Chapin Ave. Burlingame

March 27 2025 Planning Commission Study Session Comments & Responses

Response | Setbacks

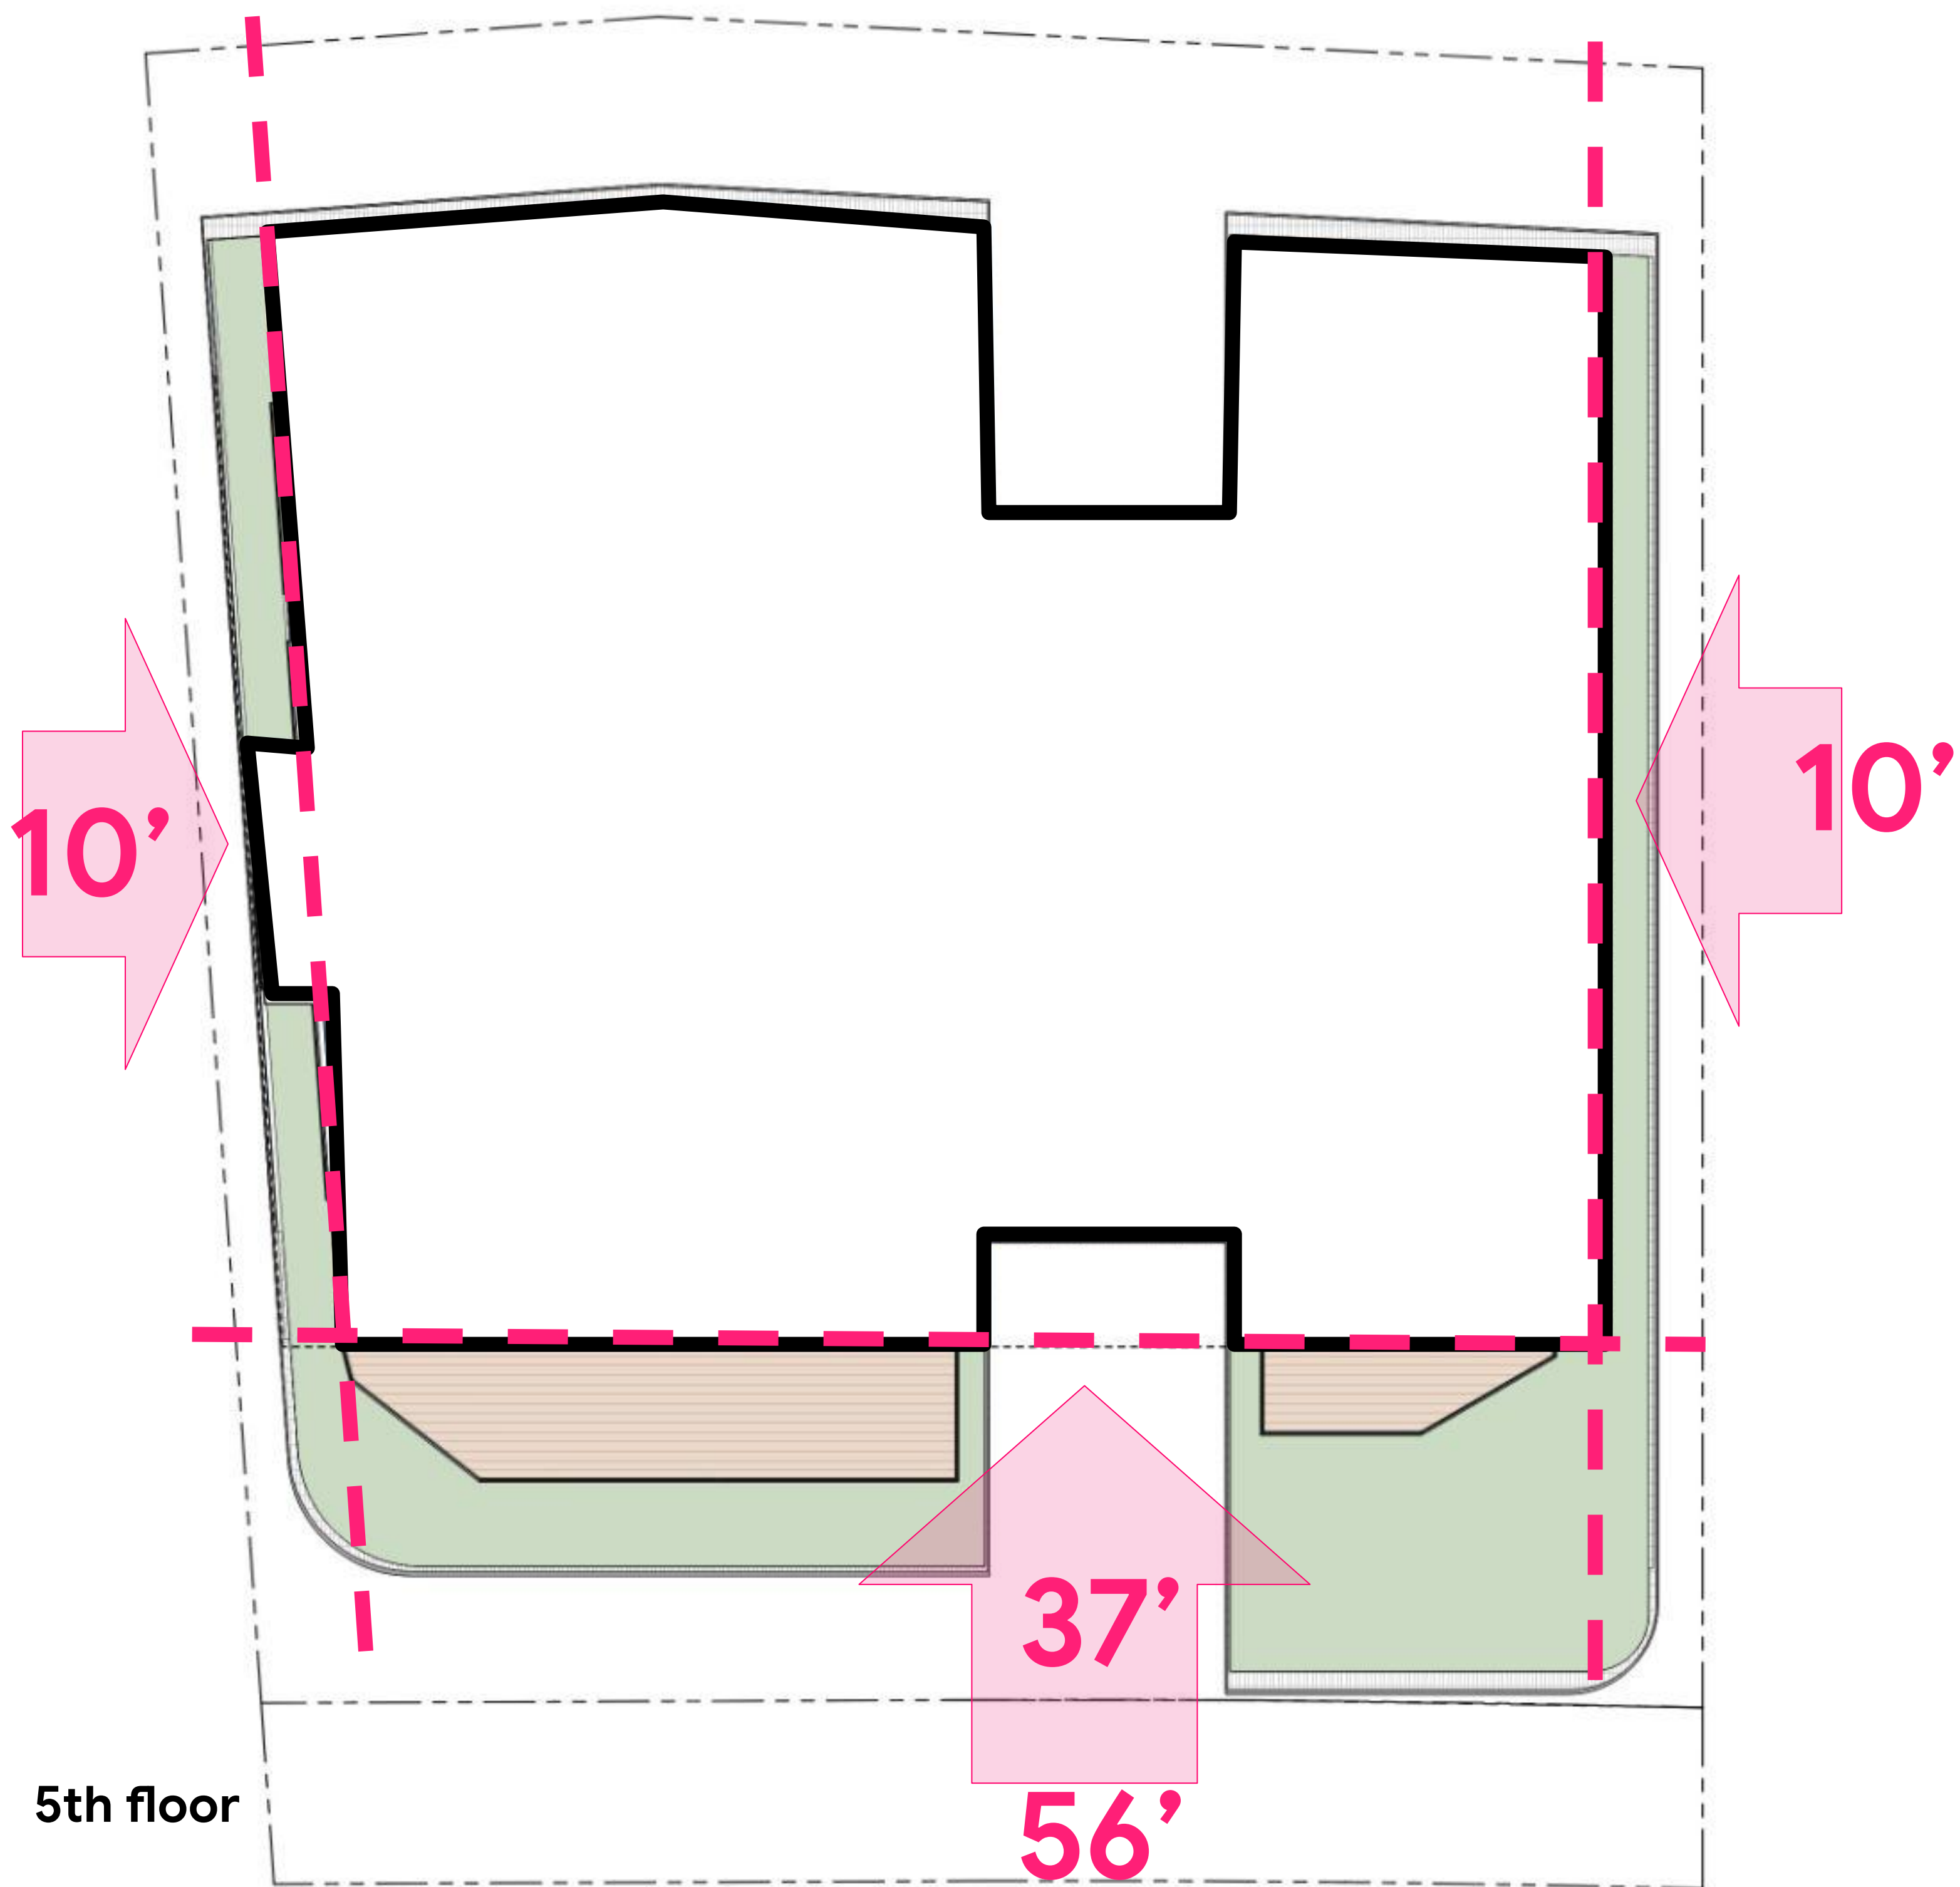
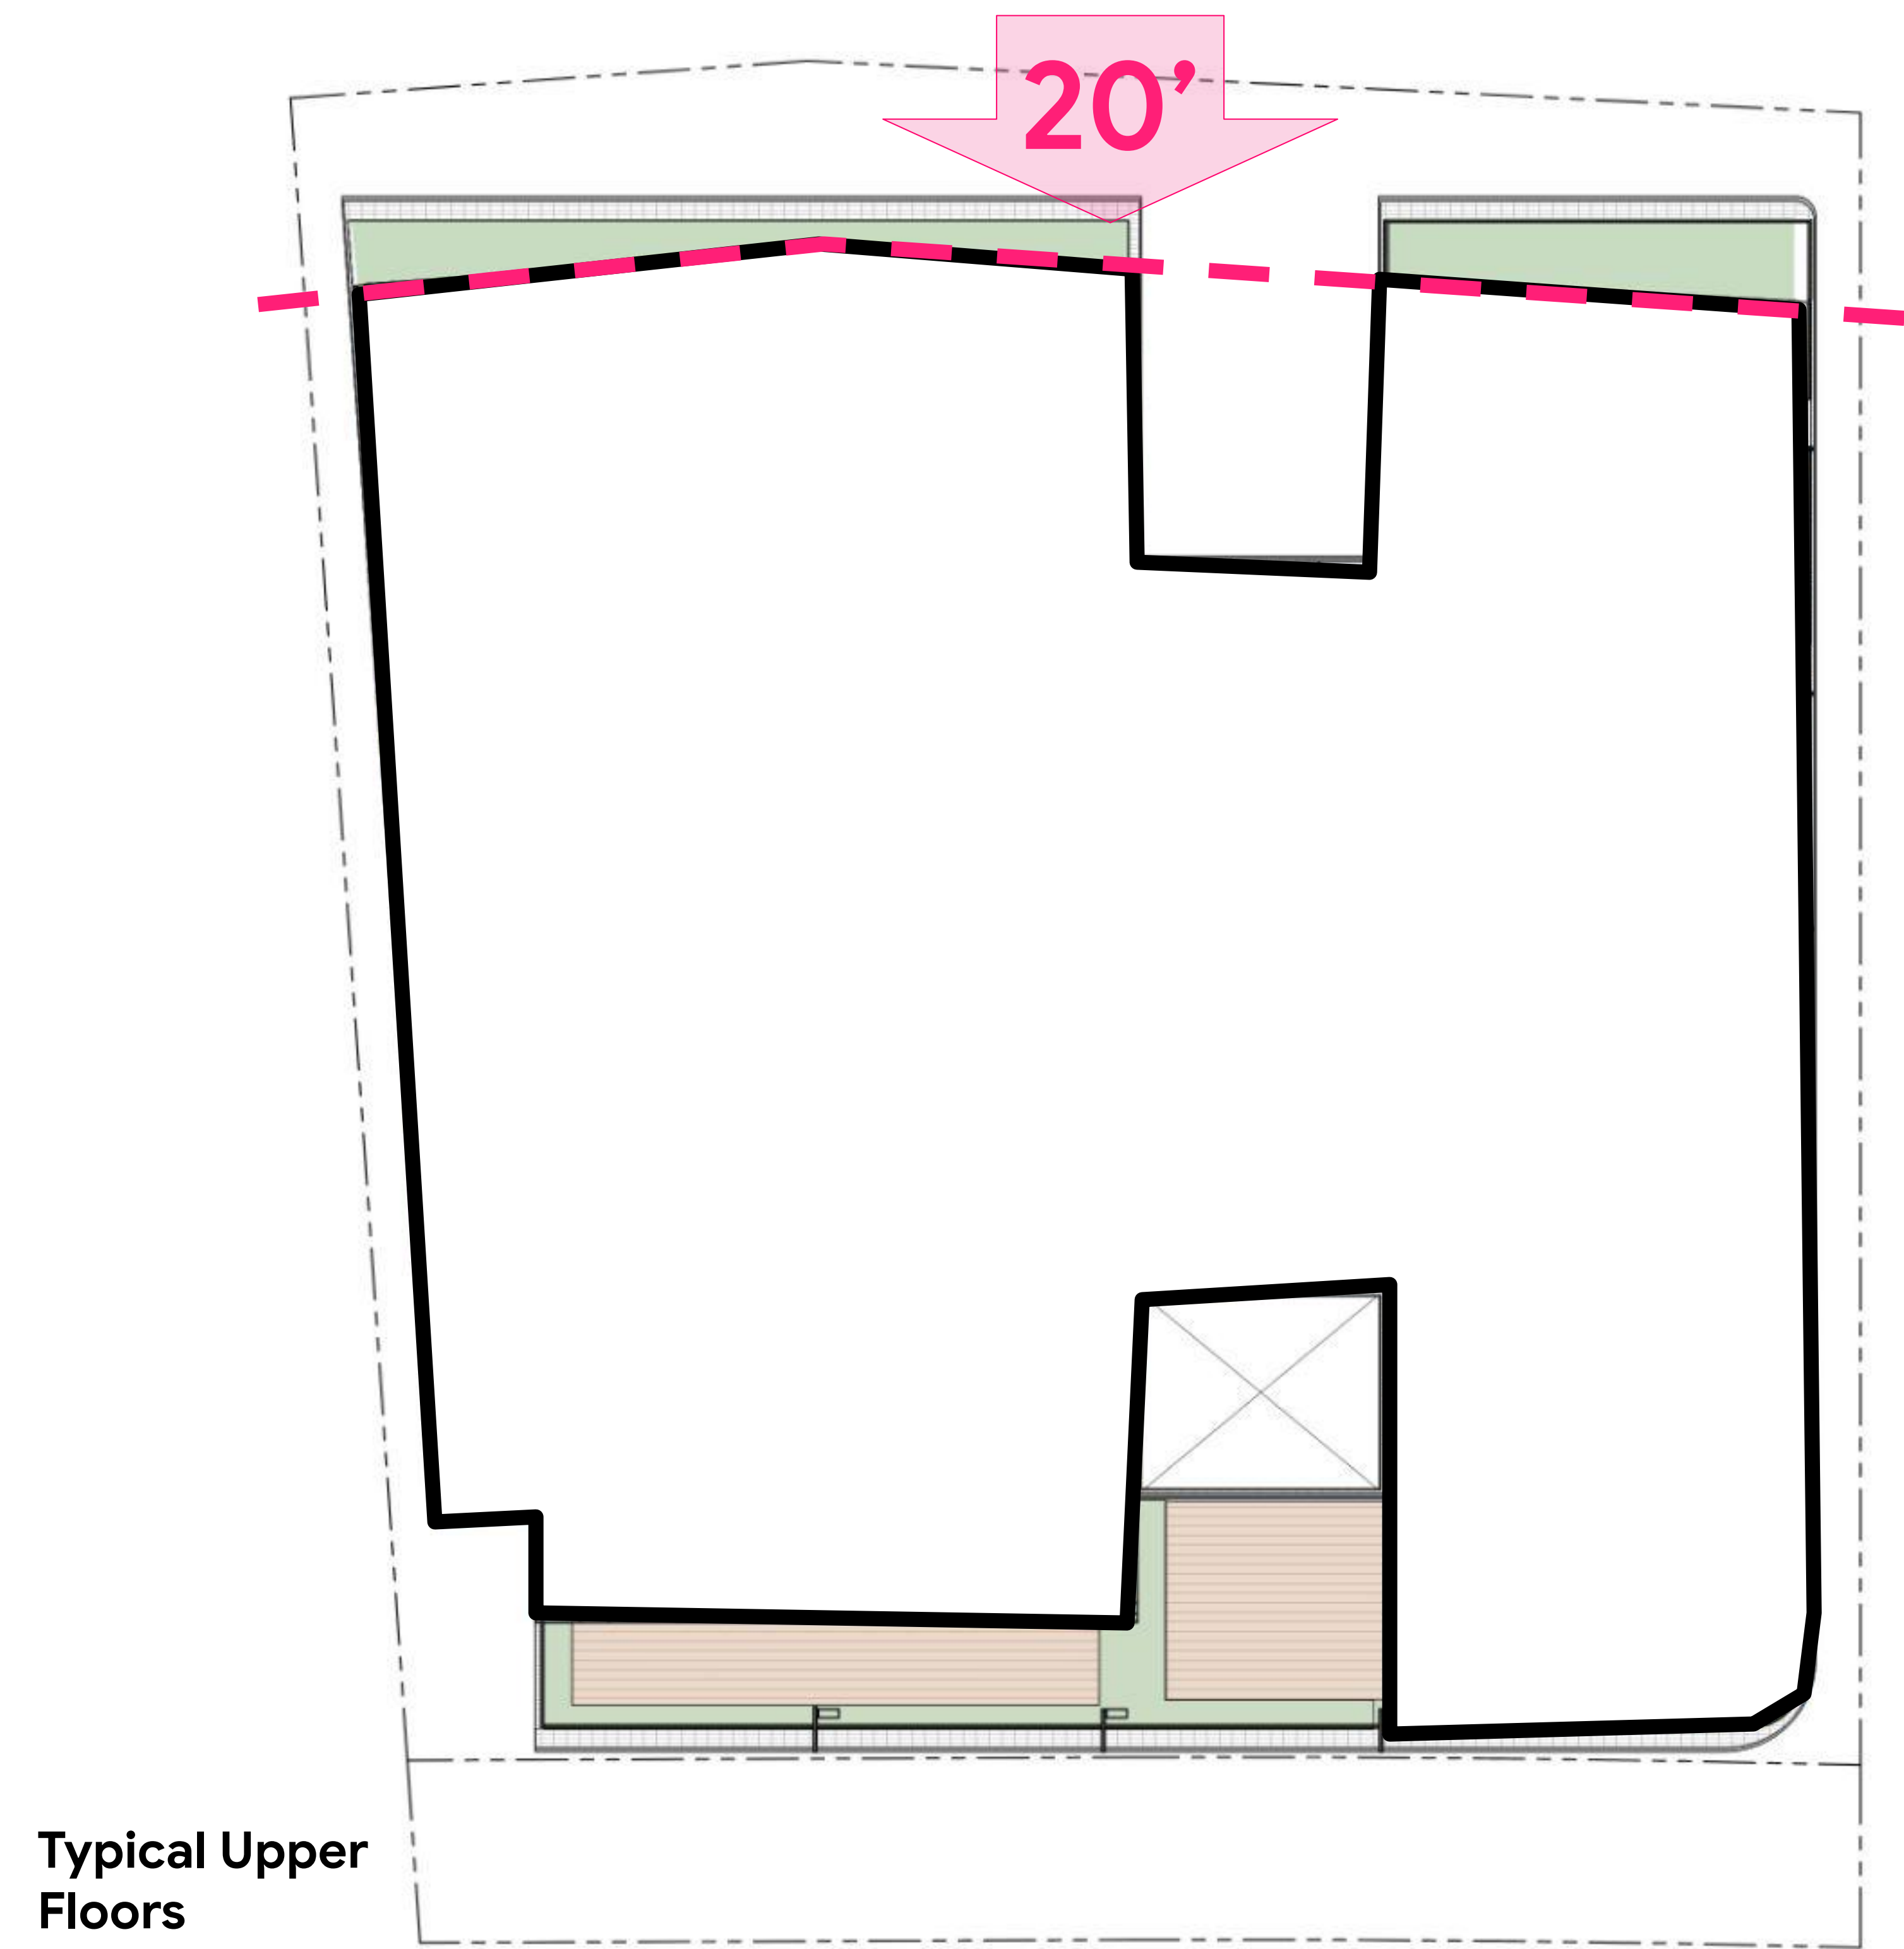
Consider a more tiered design approach on the sides to respect the neighbors.

The rear façade is stepped back to preserve a generous light and air corridor, enhancing privacy and openness for adjacent properties. At multiple levels, the building tiers in and out, integrating outdoor decks and landscaped areas that soften the overall form and bring greenery and natural light deeper into the project.

The building's top floor is stepped back even further to reduce the perceived height and visual impact of the building on all sides, utilizing setbacks that exceed current zoning requirements.

Reframing the “City of Trees” | Connected Spaces

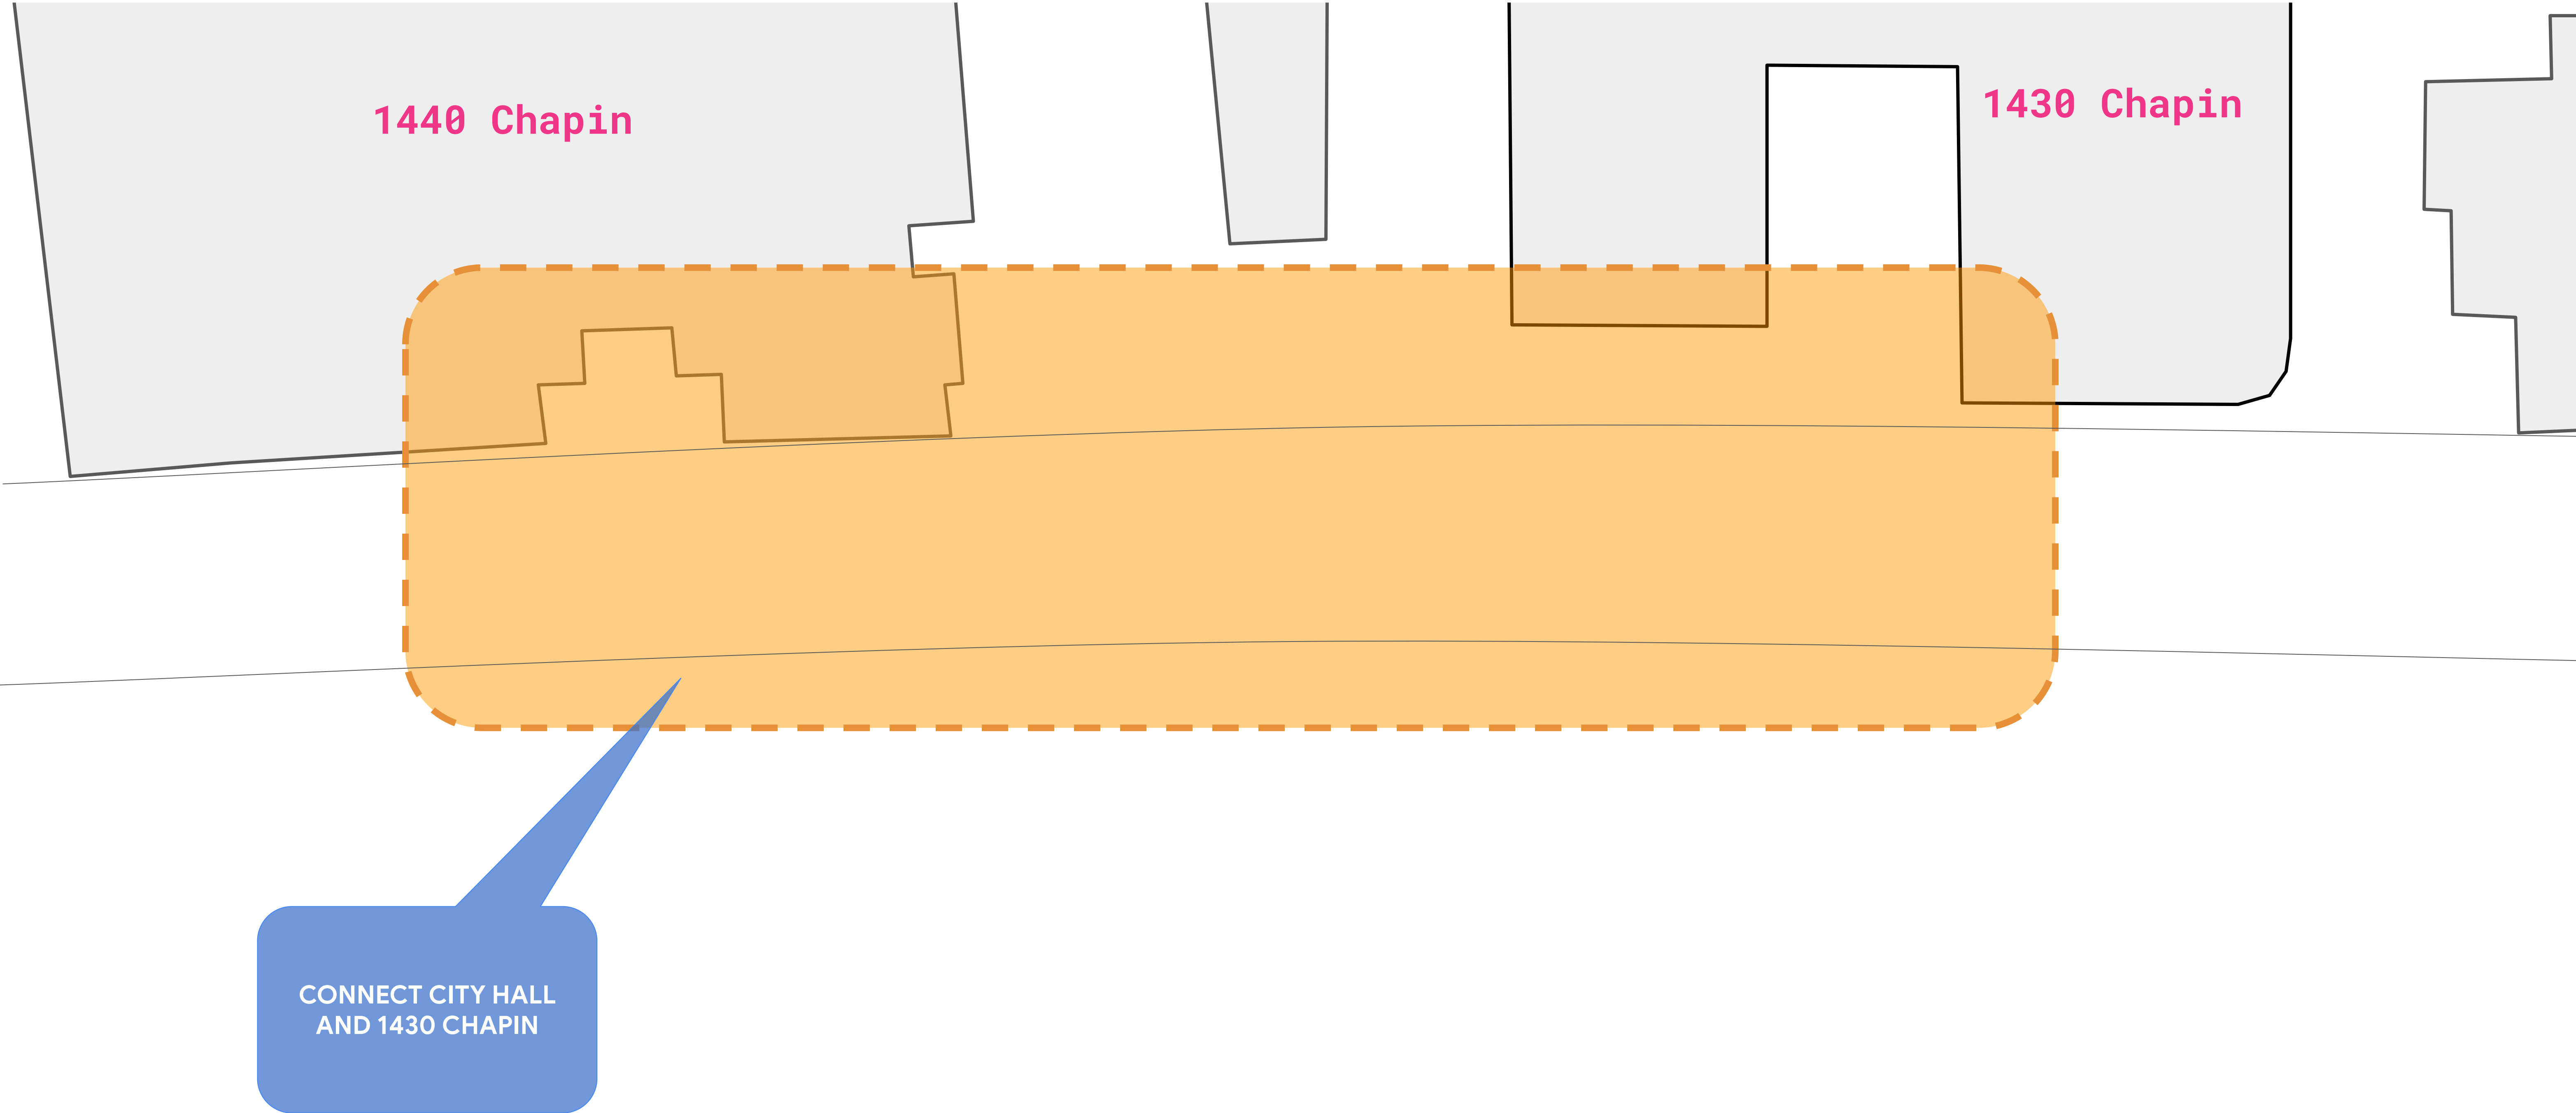
Provide some pedestrian and public benefit

In direct response to feedback from this comment and from key stakeholders, the project now includes two public plazas: one fronting the site and another adjacent to City Hall. These plazas are envisioned as pocket parks that create an engaging, human-scaled ground-floor experience and invite the community to use them as open gathering spaces.

The landscaping approach blurs the line between the built and natural environment. Using both horizontal and vertical planes, the design integrates natural landscaping seamlessly with the building's architecture. The plazas will feature native, wild-like plantings and small groves of trees along the building's edge, with pathways and connected spaces designed for gathering, respite, and exploration.
